HALIFAX DRIVE SELF STORAGE - CONCEPT 4
 COLUMBIA, TENNESSEE

CITY OF COLUMBIA TENNESSEE
 ARCHITECTURAL DESIGN REVIEW
 STAFF REPORT

ART 22-0014

This is request is for the new construction of five buildings that will house a moving operation and mini-storage buildings totaling 64,000 SF.

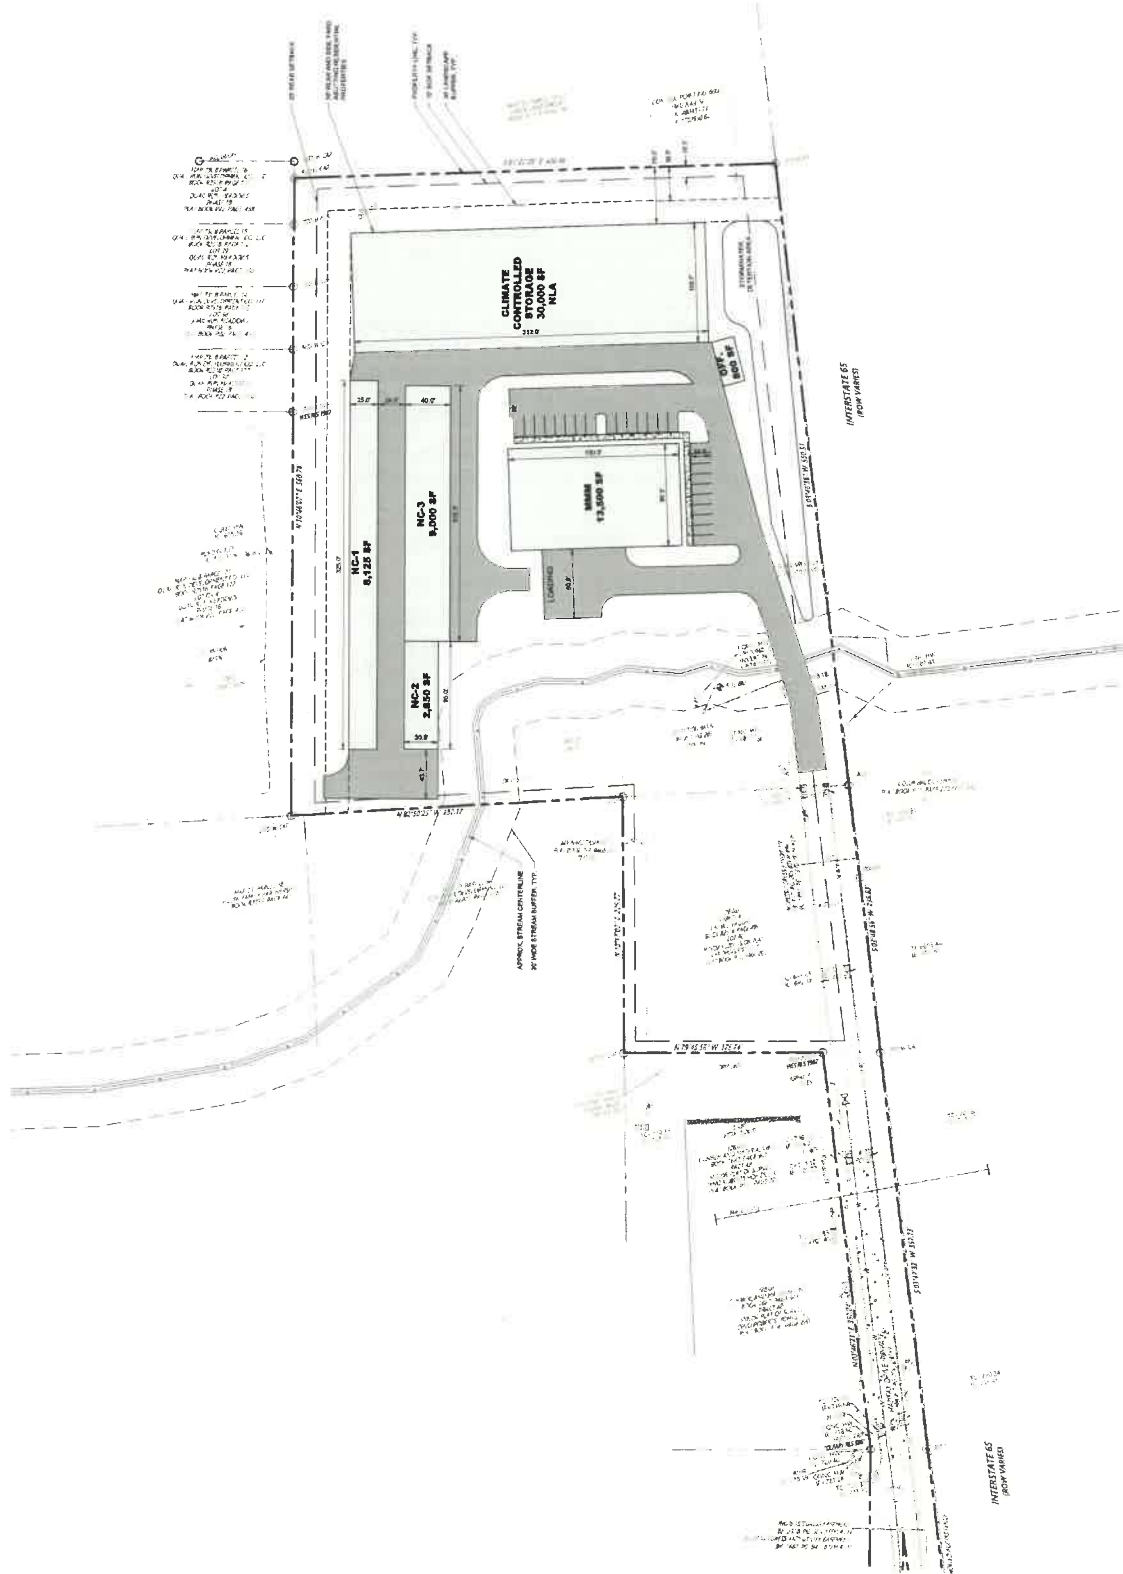
This request includes five storage buildings with all buildings having a façade material of fiber cement board (*Hardie Plank*). Please refer to attached site plan for reference.

- Building NLA will comprise of a 105 X 312 indoor self-storage structure with a maximum gable height of 20'. The façade material for the structure will consist of fiber cement board siding accented by fiber cement clad pilasters every 32'. This proposal would meet the guidelines as described for material and articulation.

- Building MMM will consist of a 90 X 150 structure with a maximum height of 19'6" at the gable. The façade material on the structure will consist of fiber cement board siding accented by fiber cement clad pilasters every 35' on the north and south elevation, with fiber cement clad pilasters every 27' on the east and west elevation. This proposal would meet the guidelines as described for material and articulation.

- Building NC-1 will comprise of a 25 X 325 structure that will serve as self-storage units with exterior access by roll-up doors. The façade material of the structure will consist of fiber cement board siding accented by fiber cement clad pilasters every 28'4" on the east and west elevations, with fiber cement clad pilasters every 28' on the east and west elevation. This proposal would meet the guidelines as described for material and articulation.

- Building NC 2-3 will be a 40 X 225 structure with an additional inset of a 95 X 30 self-storage structure. The façade material of the structure will consist of fiber cement board siding accented by fiber cement clad pilasters every 28'4" on the east and west elevations, with pilasters every 28' on the east and west elevation. This proposal would meet the guidelines as described for material and articulation.

- A 20 X 40 office building will be located on the site with a primary façade material of fiber cement board siding. This proposal would meet the guidelines as described for material. The façade has two window inserts.
